**NOTICE OF MEETING**

**Planning and Environment Committee Meeting No. 5/14**

<b>Item</b>	<b>Page</b>
1 CONFIRMATION OF MINUTES - Meeting held on 18 March 2014 .....	1
2 9 ERIC STREET, EASTWOOD. LOT 1 DP 511632. Local Development Application for demolition and erection of new dual occupancy (attached). LDA2013/0434. ....	6

**Figure 1** – Image showing the Southern (rear) Elevation of 9 Eric Street, Eastwood. The elevation demonstrates how from the rear of the property the development is three storeys in height.

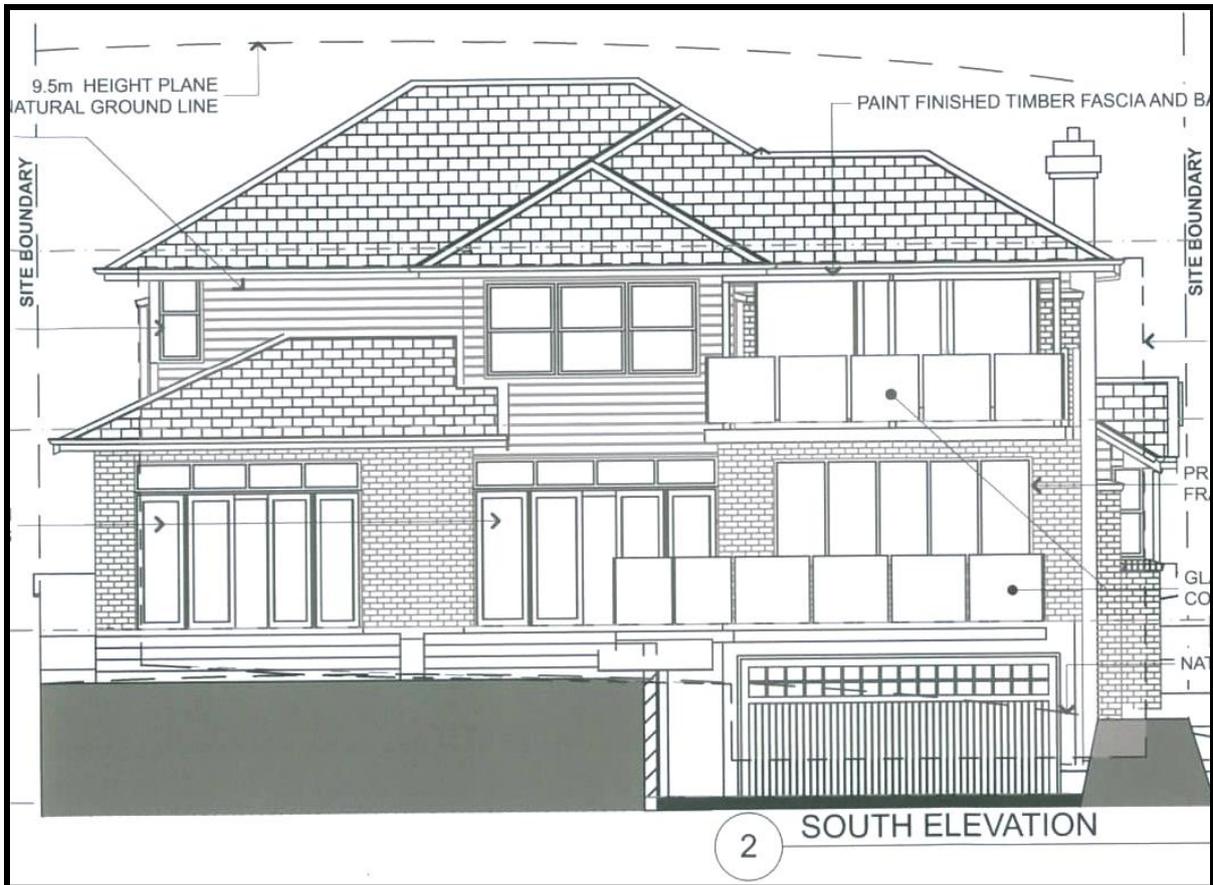
- The section of the proposed development which appears as three (3) storeys is at the rear of the property, as can be seen in **Figure 1 & 2** below. When viewed from the streetscape the proposed development appears to be a two (2) storey attached dual occupancy as can be seen in **Figures 2 and 3**. As a result, the proposed development is not considered to negatively impact upon the streetscape or present as a visually dominant development.

**Figure 2** – Section demonstrating three (3) storey component of dwelling at the rear with two (2) storeys located above the attached garage.

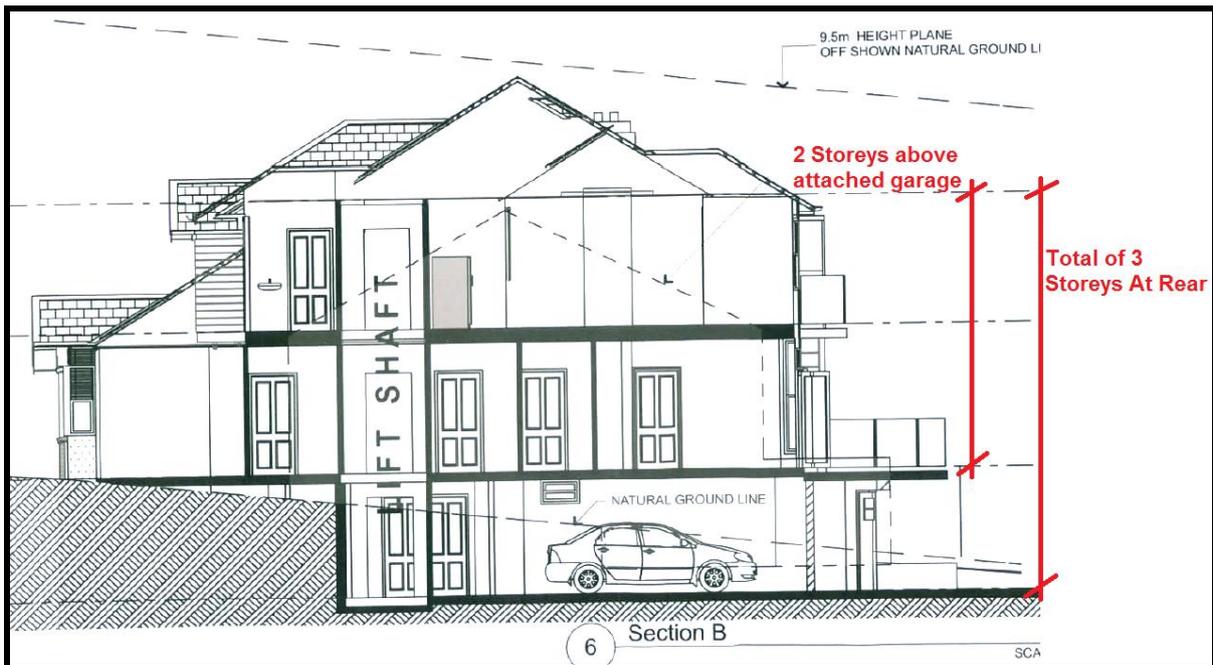
- The proposed development's semi-basement level garage is located at the rear of the property and cannot be viewed from the streetscape or any adjoining public lands. As such the two storeys above the semi-basement level garage is not considered to add to the bulk and scale of the building as it presents to the street.

**Figure 6** – Image showing the Western Elevation of 9 Eric Street, Eastwood with highlighted areas demonstrating non-complying portion of the Family Room wall and the Family Room Window location.

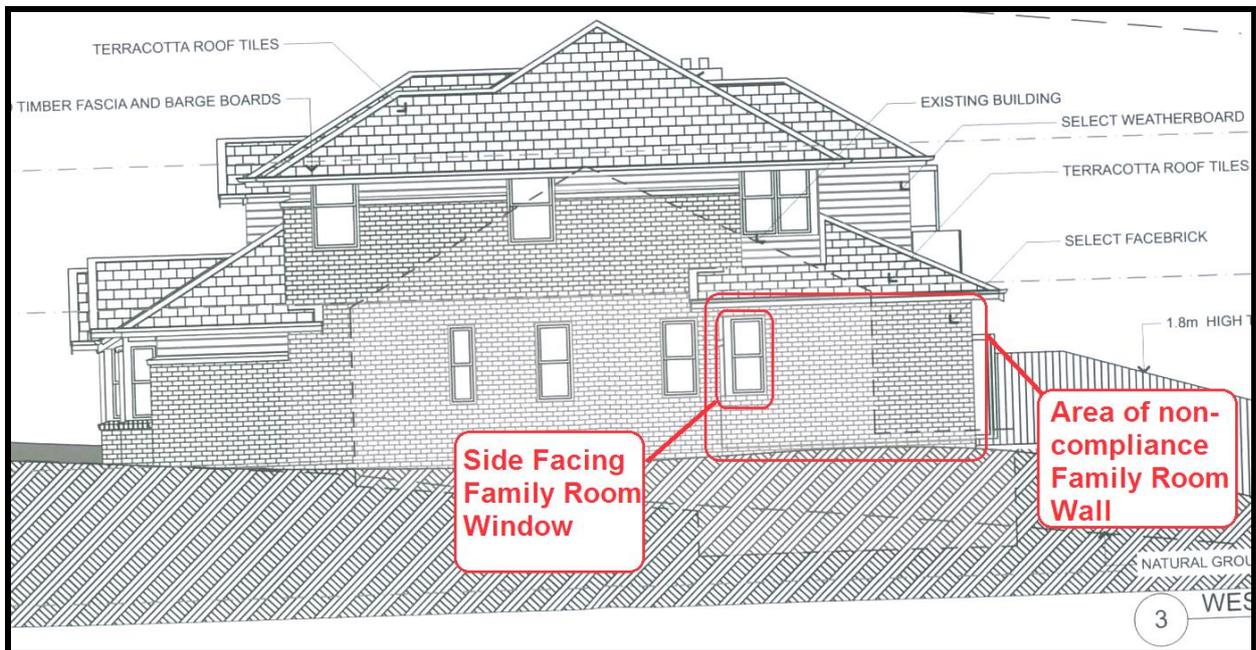
- The eastern side boundary setback non-compliance will have no adverse impact on the neighbouring properties privacy as a result of the further setback provided by the Right of Carriageway.
- The western side boundary setback non-compliance occurs along a 4.8m stretch of building. This non-compliance occurs in the family room of dwelling two and there is only one small side facing window in this section of wall, as can be seen in Figure 6 below. This window is not considered to cause any unnecessary privacy impacts on the adjoining property due to its size, dimensions and location at the rear of the family room – an area which is unlikely to be heavily trafficked. The sole purpose of this window is to allow solar access to the family room.

- The western side boundary of the subject site is adjacent to the registered Right of Carriageway for Lot 2 DP747810, as can be seen in Figure 5 above. This Right of Carriageway is approximately 3m wide and cannot be developed on by Lot 1 or Lot 2 of DP747810 without prior written consent. As such if including the Right of Carriageway in the calculation of the western side setback it is increased to between 3.8m and 4.519m.

**Figure 7** – Image showing the basement level floor plan of 9 Eric Street, Eastwood. The floor plan indicates the proposed location of the three (3) on-site car parking spaces.

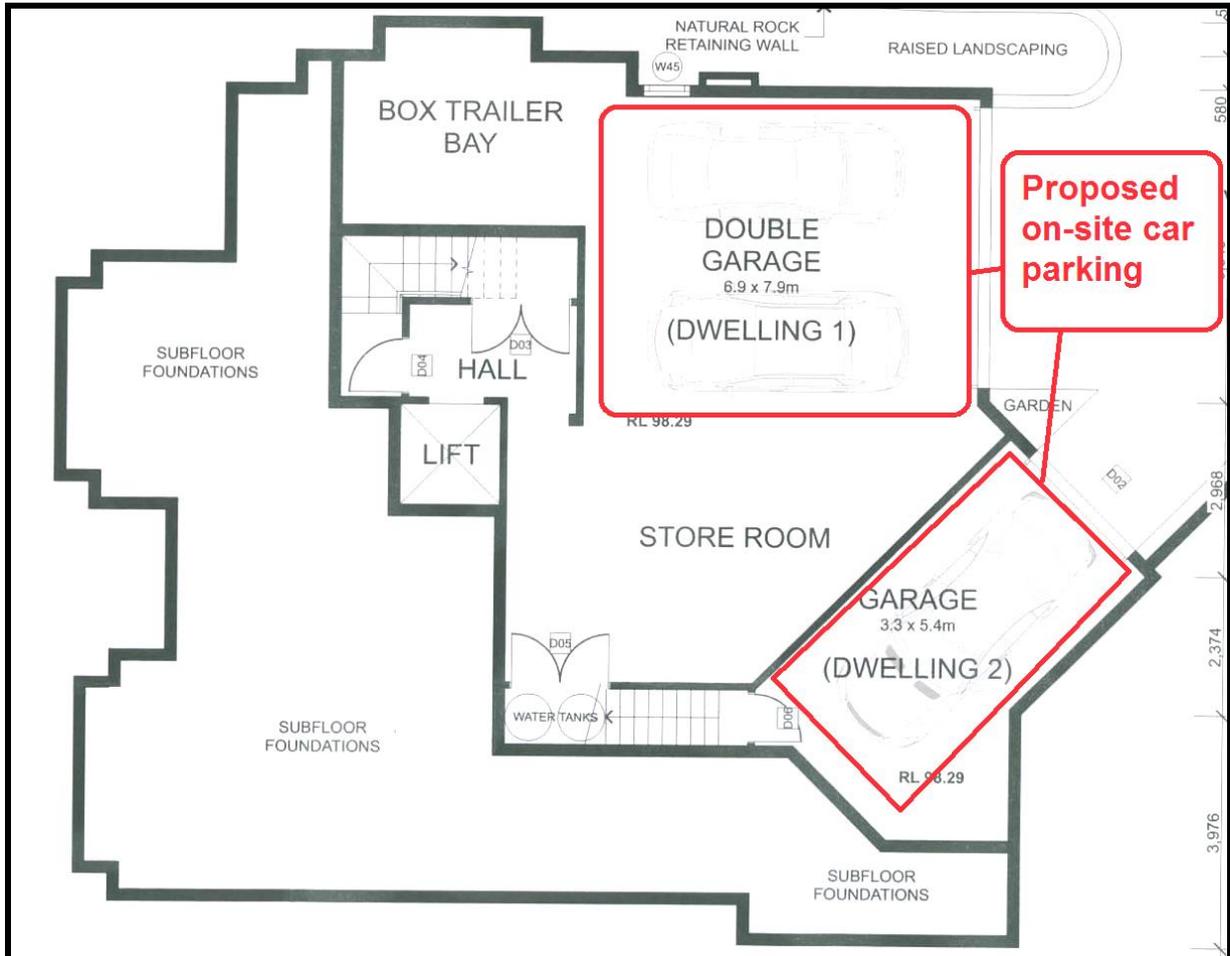
An assessment of the submitted architectural plans indicate that three (3) car spaces are proposed for the attached dual occupancy, which is in excess of the controls as can be seen in **Figure 7**.

Although exceeding the maximum number of car parking spaces allowed per dual occupancy this non-compliance can be supported for the following reasons:

- The location of the garage and car parking at the rear of the site ensures that whilst in excess of the control there is no impact on the streetscape in terms of excessive visual bulk resulting from garages dominating the front façade .
- The attached dual occupancies proposed on site are suitable for larger households, who will be likely to require more than one vehicle.
- There are no privacy, amenity, noise or other impacts on the adjoining properties as a result of this non-compliance.

**Figure 8** – Image showing the ground level floor plan of 9 Eric Street, Eastwood. The floor plan indicates the south facing living areas of dwelling 1 and 2.

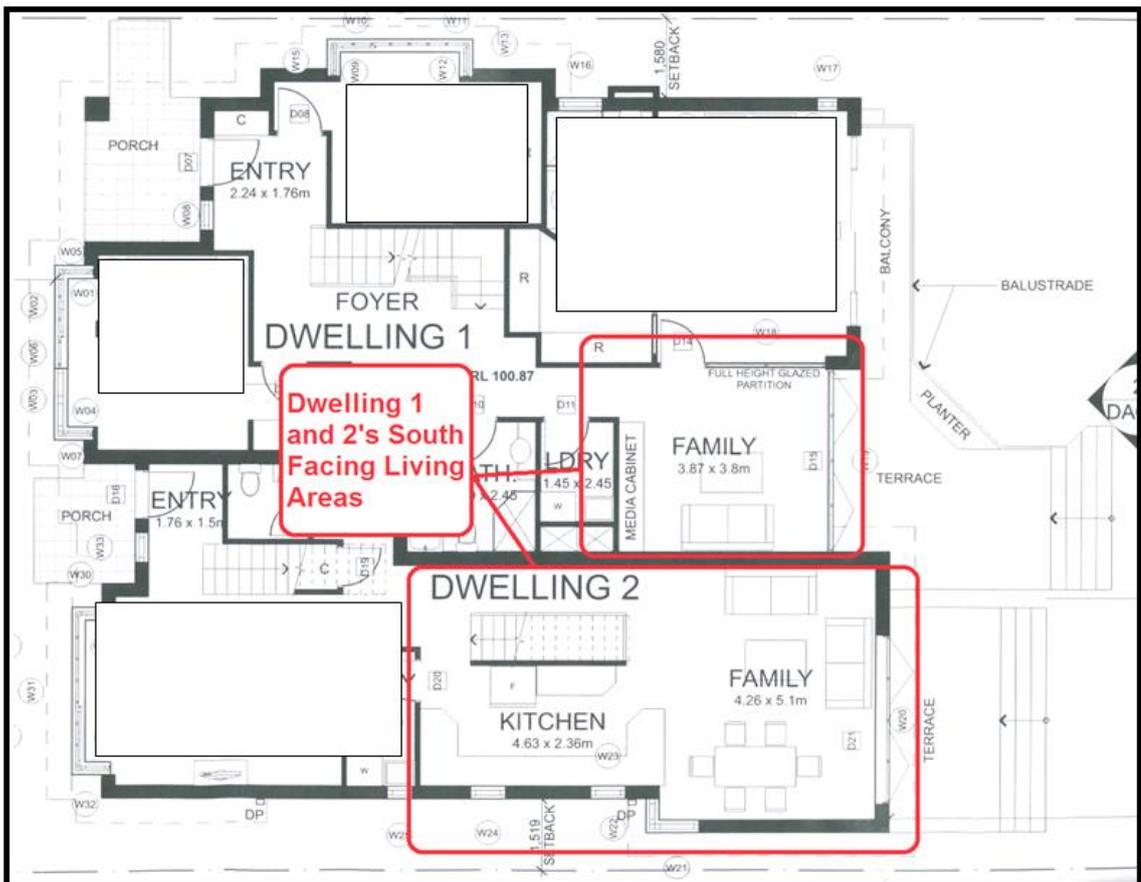
The submitted architectural plans and shadow diagrams indicate that the proposed development does not have living areas predominately located to the north of the site as can be seen in Figure 8 and 9 below. Nor does the entire of the subject site's private open space receive at least two hours of sunlight between 9am and 3pm on June 21 as can be seen in **Figure 10-12** below.
